Access Compliance Report Public Rights-of-Way (Pedestrian Signals)

Intersection ID: N/A	Main Street:	Cross Street: N/A	Location: N/A
ADA ID: 07AA5F17AF03	Signal Type: One Push Button-APS	Overall Compliance: No	Severity Score: BTN 1: N/A BTN 2: N/A No BTN: N/A
Codes/Mitigation Info/Possible Solution		Field Measurements/Component Compliance

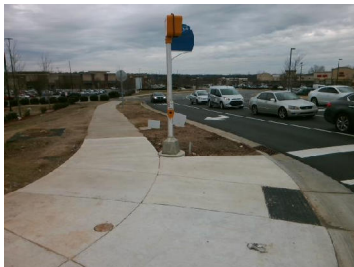
PROW/ADA: TMUTCD 4e.08, R404.2, R404.3, R404.7.2, R209.1, MUTCD 4e.10

N/A	B 1 FWD Approach Width (in)	N/A	N/A	B 2 FWD Approach Width (in)	N/A
N/A	B 1 FWD Approach Obstruction?	Yes	N/A	B 2 FWD Approach Obstruction?	N/A
N/A	B 1 FWD Approach Obstruction Dist (in)	2.0	N/A	B 2 FWD Approach ObstructionDist (in)	N/A
N/A	B 1 PARA Approach?	Yes	N/A	B 2 PARA Approach?	N/A
N/A	B 1 PARA Approach Constrained?	Yes	N/A	B 2 PARA Approach Constrained?	N/A
Yes	B 1 PARA Approach Reach (in)	6.0	N/A	B 2 PARA Approach Reach (in)	N/A
No	B 1 PARA Approach Width (in)	48.0	N/A	B 2 PARA Approach Width (in)	N/A
N/A	B 1 PARA Approach Obstruction?	Yes	N/A	B 2 PARA Approach Obstruction?	N/A
N/A	B 1 PARA Approach Obstruction Dist (in)	3.0	N/A	B 2 PARA Approach ObstructionDist (in)	N/A
No	B 1 Clear Floor Space Slope (%)	2.5	N/A	B 2 Clear Floor Space Slope (%)	N/A
No	B 1 Clear Floor Space XSlope (%)	4.6	N/A	B 2 Clear Floor Space XSlope (%)	N/A
N/A	B 1 PAR Slope (%)	N/A	N/A	B 2 PAR Slope (%)	N/A
Yes	B 1 Height (in)	38.0	N/A	B 2 Height (in)	N/A

N/A	B 1 Clear Xing Direction?	Yes	N/A	B 2 Clear Xing Direction?	N/A
	B 1 Crossing Direction	To N		B 2 Crossing Direction	N/A
No	B 1 DistanceTo XWalk (in)	80.0	N/A	B 2 DistanceTo XWalk (in)	N/A
No	B 1 DistanceTo Curb (in)	73.0	N/A	B 2 DistanceTo Curb (in)	N/A
Yes	B 1 Diameter (in)	2.0	N/A	B 2 Diameter (in)	N/A

Possible Solutions: Replace Signal Push Button With APS Button on New Post. Remove & Relocate Sign.
